UNITED STATES PATENT AND TRADEMARK OFFICE

APPLICATION NO.	FILING DATE	FIRST NAMED INVENTOR	ATTORNEY DOCKET NO.	CONFIRMATION NO.
10/534,956	04/27/2007	Paul A. Kohl	GTR206-0002	1856
55165	7590	05/18/2011		
PROMERUS, LLC				
9921 BRECKSVILLE ROAD				
BRECKSVILLE, OH 44141				
EXAMINER				
GEBREYESUS, YOSEF				
ART UNIT		PAPER NUMBER		
2811				
MAIL DATE		DELIVERY MODE		
05/18/2011		PAPER

Office Action Summary**Application No.**

10/534,956

FIG. 1

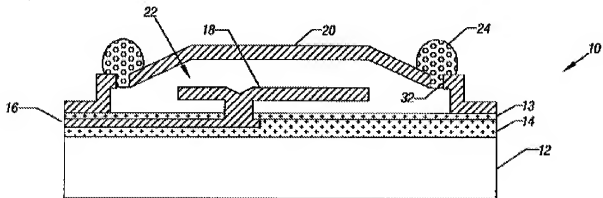
32. Regarding **claim 24**, figures 1-8 (one embodiment) and related text of Heck discloses forming a thermally decomposable sacrificial layer 15 and 25 (paragraph [0015]) on a substrate 12 of a micro electro-mechanical device 18, the sacrificial layer 15 & 25 encapsulating a portion of the micro electro- mechanical device 18 (paragraph

[0013]); said sacrificial layer is patterned (paragraph [0016] and [0017]); forming a contiguous overcoat layer (cover) 20 (the cover is formed without openings 32) (paragraph [0018], [0021]) around the sacrificial layer 15 & 25; and thermally decomposing the sacrificial layer (paragraph [0015]), wherein decomposed molecules of the sacrificial layer permeate through the overcoat layer 20 (paragraph [0021]), and wherein a gas cavity 22 (paragraph [0014]) is formed where the thermally decomposable sacrificial layer 15 & 25 was formed, wherein the contiguous overcoat layer 20 provides an airtight (hermetic seal or vacuum cavity) (paragraph [0014] lines 11-15) and enclosure around the gas cavity 22 (paragraph [0014]).

Heck teaches the sacrificial material is polynorbornene (paragraph [0015]). Heck does explicitly disclose the sacrificial layer is photodefinable and image wise exposing to form a pattern.

However, in the same field of endeavor, figures 1A-1C and related text of Mule discloses using a photodefinable (photosensitive polynorbornene) (paragraph [0055])

material as a sacrificial layer and forming a pattern by using an image wise exposing method (ultra violet radiation) (paragraph [0058]).

Therefore, it would have been obvious to one of ordinary skill in the art at the time the invention was made to form the pattern of Heck's device by using an image wise exposing method as taught by Mule. The ordinary artisan would have been motivated to use such method because it is conventional and known in the art to form patterns by exposing to light.
